# Change Order Request

#0348- Rineyville Elementary School  
275 Rineyville School Rd  
Rineyville, KY 40162

Change Order Request: 076

Add new gutter and downspout to the Student Entry Canopy at Door 188C

MOD.  
46

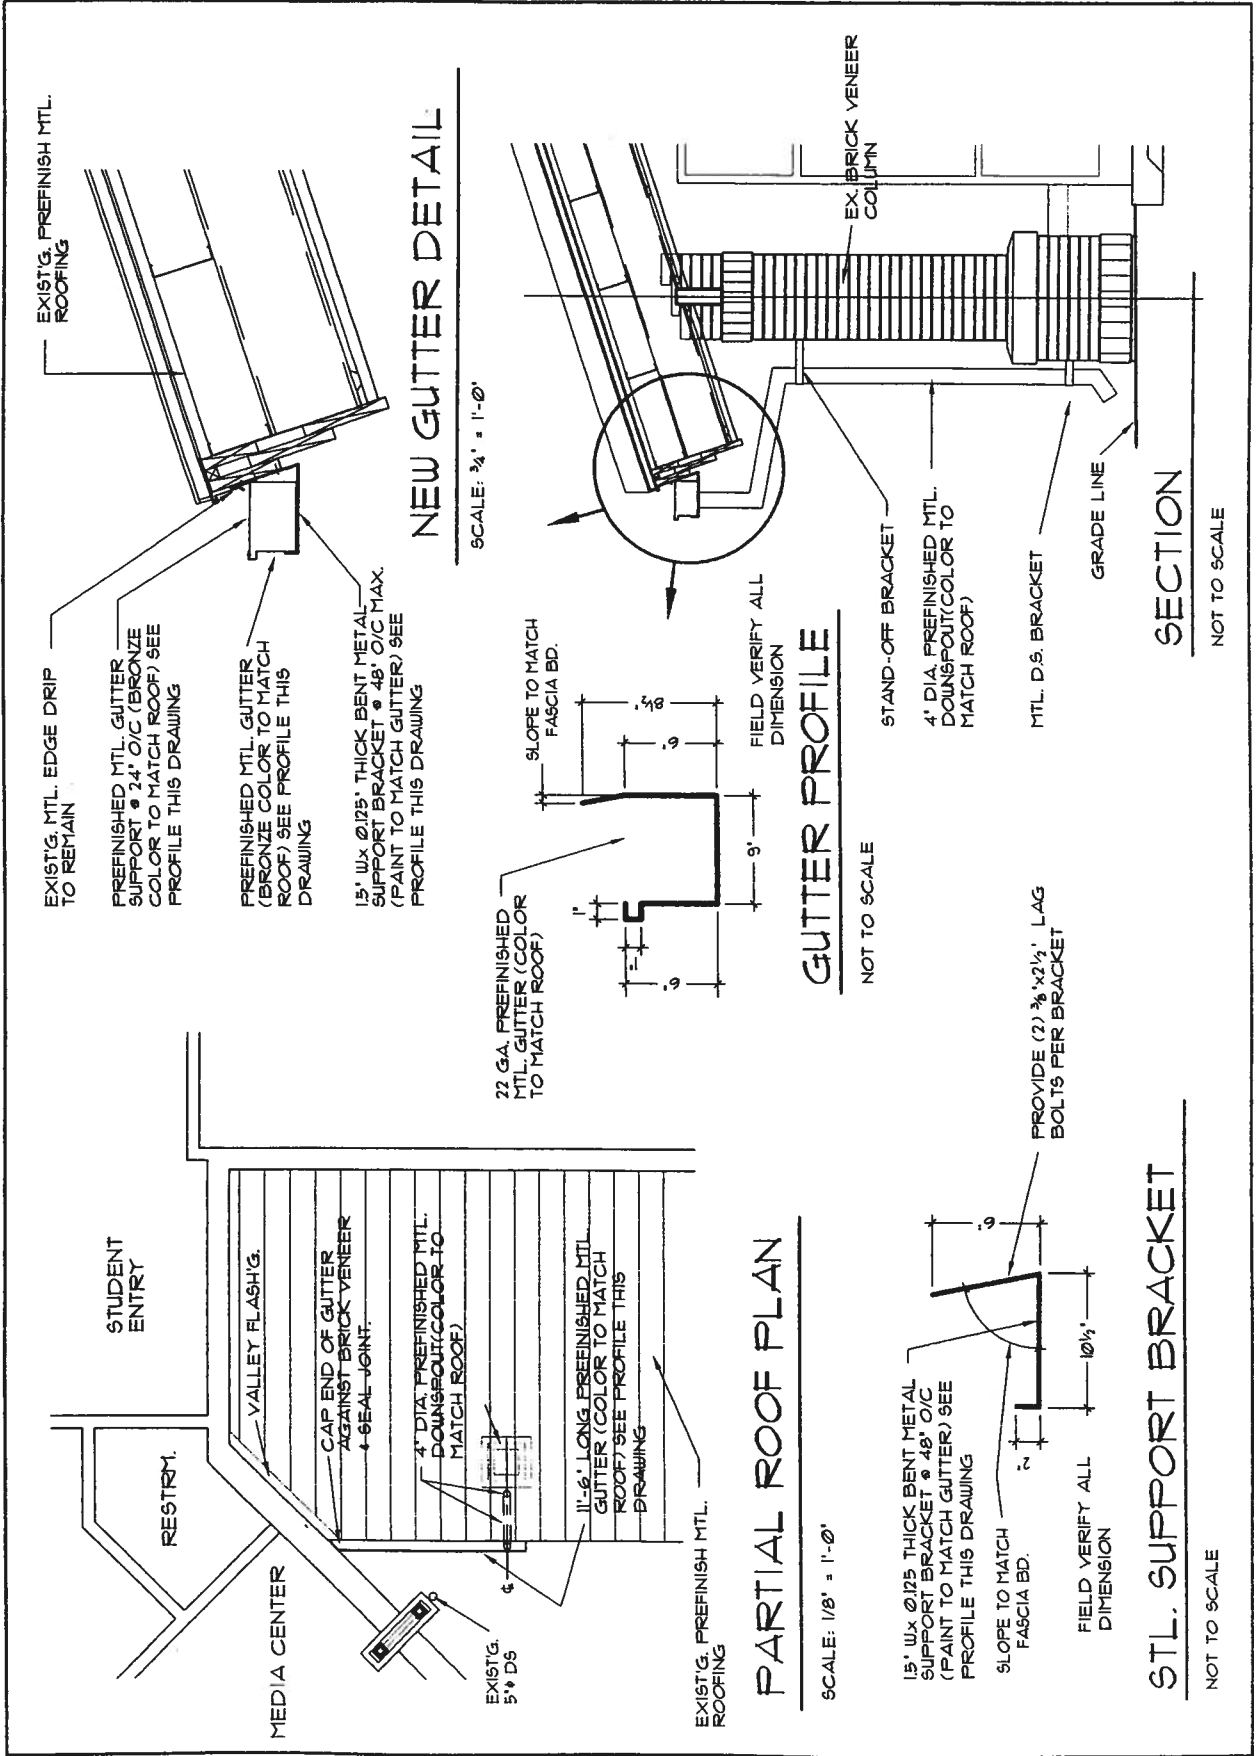
The support brackets will be 2" x .125" SS bar painted to match the gutter. They would be spaced 36" O.C. alternating w/the gutter spacers 36" O.C.

The downspout will be 5" round to match the rest of the downspouts on the project.

# WALL MOUNT ENCLOSURE 100 Series - Compact

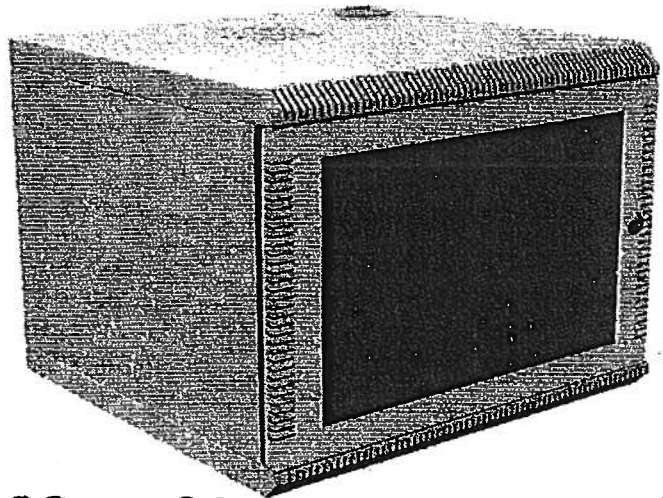
NOTE: COLOR  
SELECTION BY  
ARCHITECT. NEED  
ASAP.

Refer to Revision Drawing to Sheet M-1:

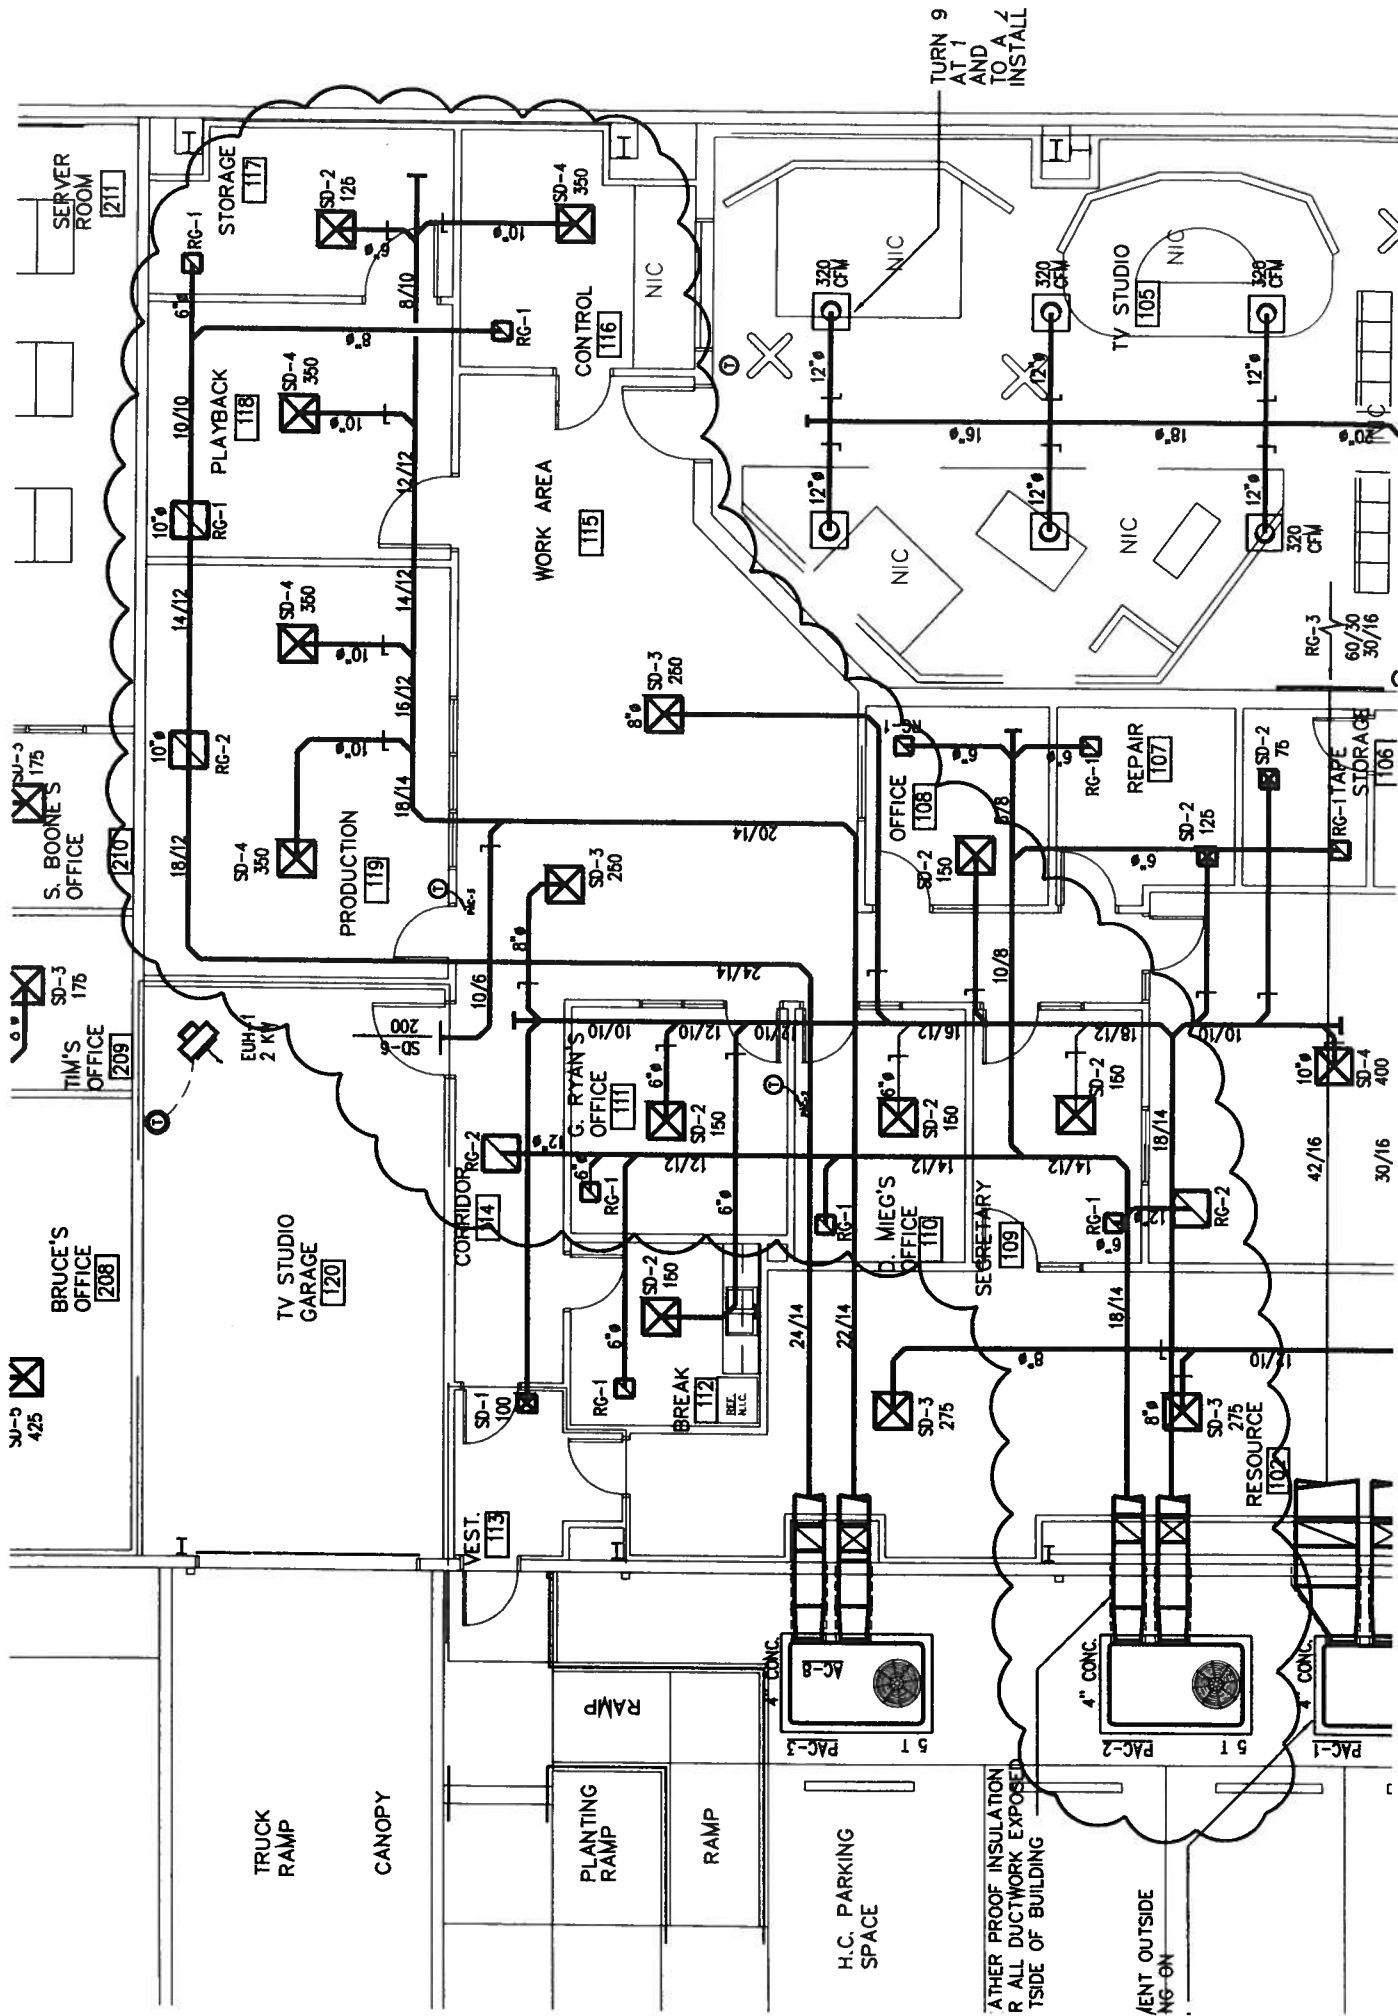
1. Change PAC-2 from 4 to 5 ton to include air to Work Area 115.
2. Remove work area air supply from PAC-3. See revised ductwork/air devices.
3. The existing unit requires 21.2 amps and is currently being served by a 30 amp circuit. The new unit requires 30 amps and will be served by a 45 amp circuit.
4. Replace existing conduit and wiring with new conduit that will accept # 8 conductors and furnish a new 60-amp W/P fusible disconnect with 45 amp fuses.
5. The existing circuit breaker supplying power to this circuit will need to be replaced with a 50 amp breaker.
